April 20, 2022

Windsor 2300 Request for respectful porch addition.

We are writing to request permission to make the changes presented below, each followed with the reference information to support the request: (Architectural drawings contain historical and new drawings for review).

TYPE
A

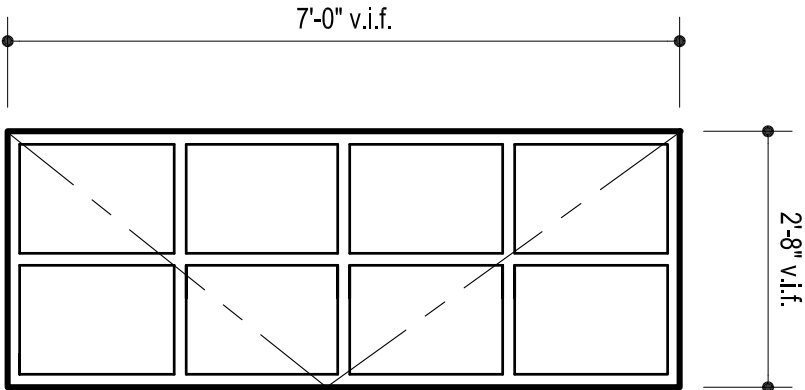
pntd steel door in historical opening.
Door Type H on historica schedule
indicates this door would have been
7'-0" x 2'-8"

TYPE
B

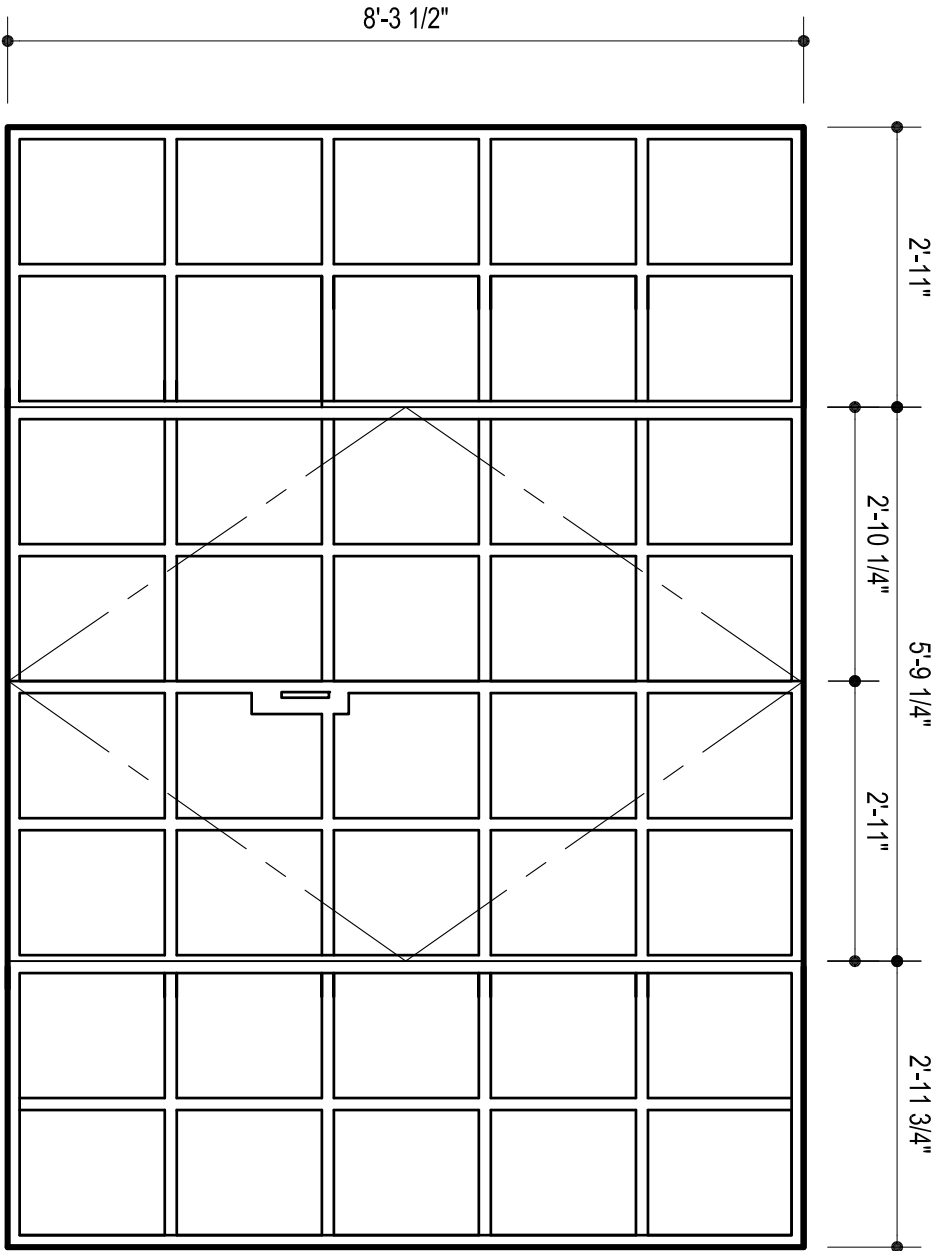
pntd steel door in existing opening.

TYPE
C

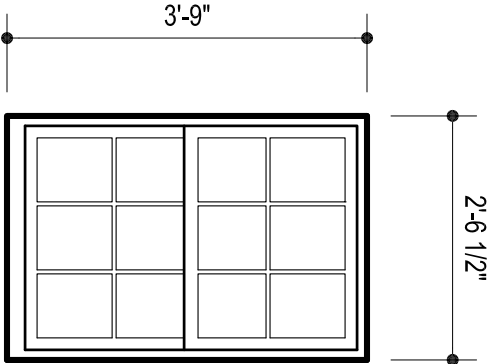
new dbl hung window to match
existing windows in manufaturer,
color and finish.
Marvin Aluminum Clad Windows.
See Spec in Appendix.

1 LIGHT WELL
ACCESS PANEL DETAIL
1-1/2" = 1' SCALE

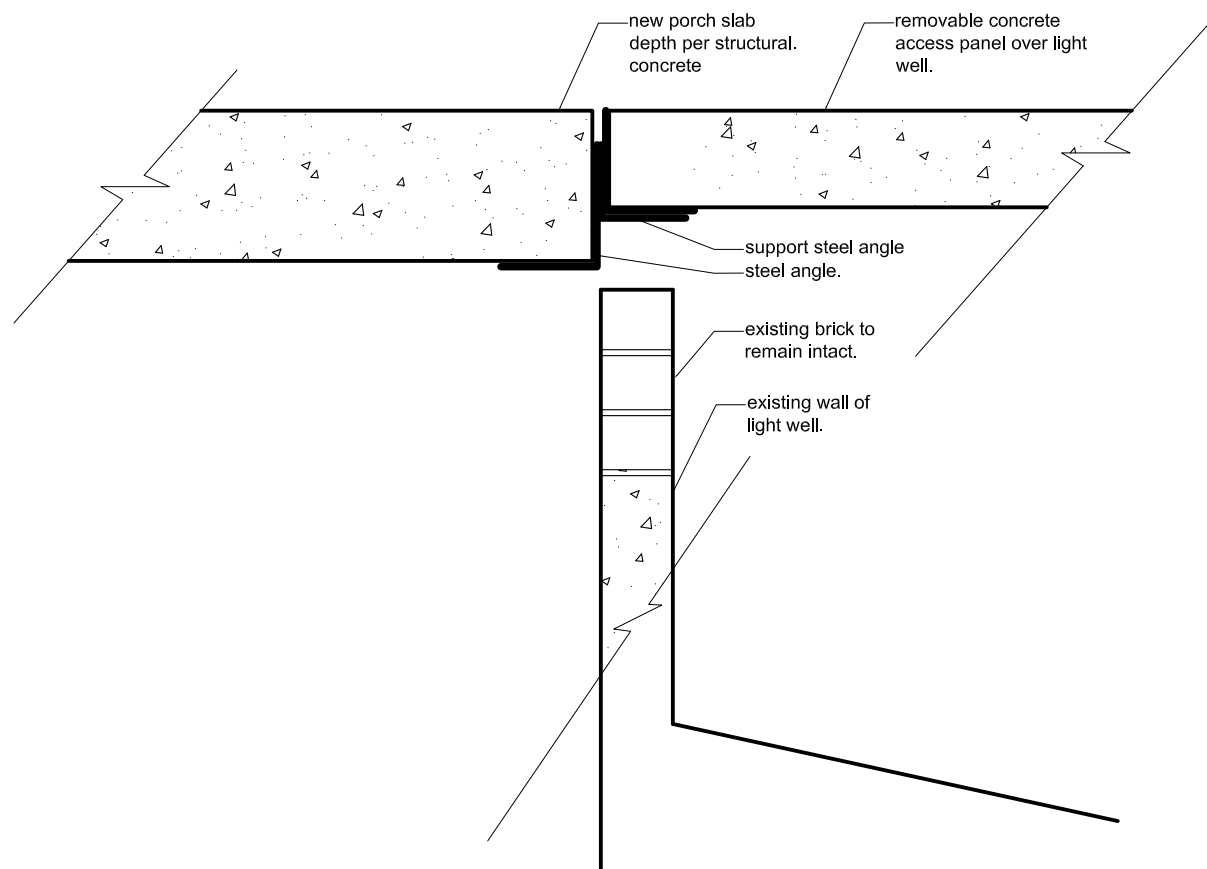
- ii. Refer to Appendix 4c. **iii. Refer to Door Type 'C' on 'Gate, Door, and Window Type'**
- d. Light Well on rear elevation of house to be covered by new porch but remain accessible for maintenance.
